NOTIFICACIÓN NÚM. 2

SUBASTA FORMAL 23J-12467 SERVICIOS DE REMODELACIÓN DE EDIFICIO CARIBE PLAZA PROPIEDAD DEL SISTEMA DE EMERGENCIAS 911, ADSCRITO AL DEPARTAMENTO DE SEGURIDAD PÚBLICA DEL GOBIERNO DE PUERTO RICO

ASUNTO: CONTESTACIÓN DE PREGUNTAS

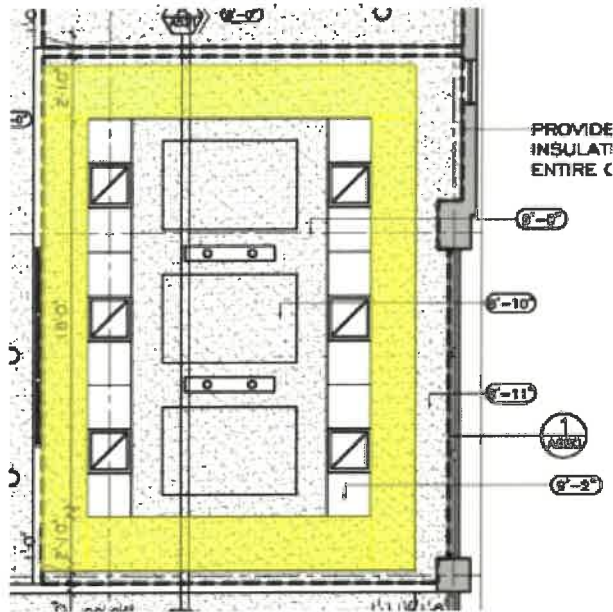
26. Do all floor levels need 2’’ roll insulation over the entire ceiling area?

Answer: Only in the areas that are marked on sheets A-6.20, A-6.30, A-6.40, A-6.50, A-6.60 as amended attached to the Amendment No. 6.

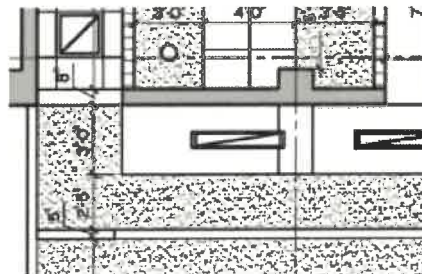
27. Some of the ceiling heights are not provided in the reflected ceiling plans, therefore creating a confusion regarding the heights of the possible transition/fascia that may be needed. One example is the ceiling from conference room #210 (found on page A-6.20). The marked ceiling (in yellow) does not have an assigned height. Please provide these dimensions, to develop a complete take-off.

Answer: The dimensions are 8'-10". See sheets A-5.21 and A-6.20 as amended attached in Amendment No. 6, for more details.

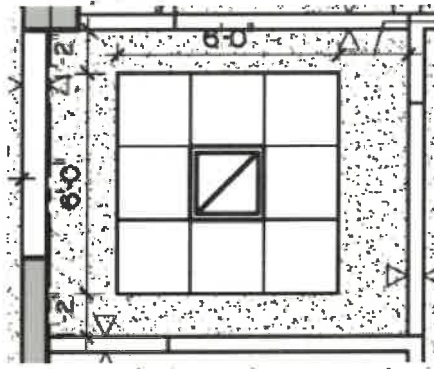
29. What is the difference in height between finish C-1 & C-3 in the waiting area #209 (please refer to page A-6.20)? In the finish schedule (page A-4.21), finish C-3 is not marked, but it is represented in the reflected ceiling floor plan. Which specification prevails?

Answer: They are currently marked. See sheets A-4.21 and A-6.20 as amended attached to Amendment No. 6.

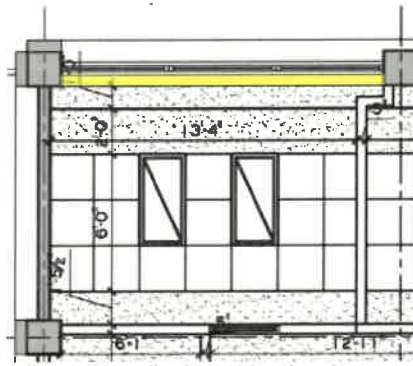
30. Are these spaces left in blank on purpose (as in, are they supposed to be considered as 'open to ceiling')? The example shown is from the file room #401, found in the 4th level reflected ceiling plan.

Answer: It would be an existing concrete beam at 8'-11".

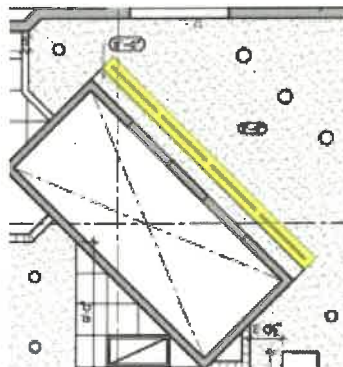
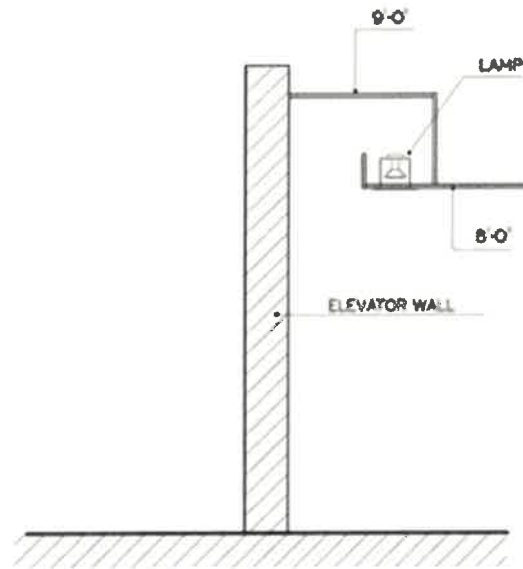
31. Is the part that is not shaded (painted in yellow) considered as 'open to ceiling'? The example shown occurs in every elevator lobby.

Answer: It is not 'open to ceiling'. See attached drawing.
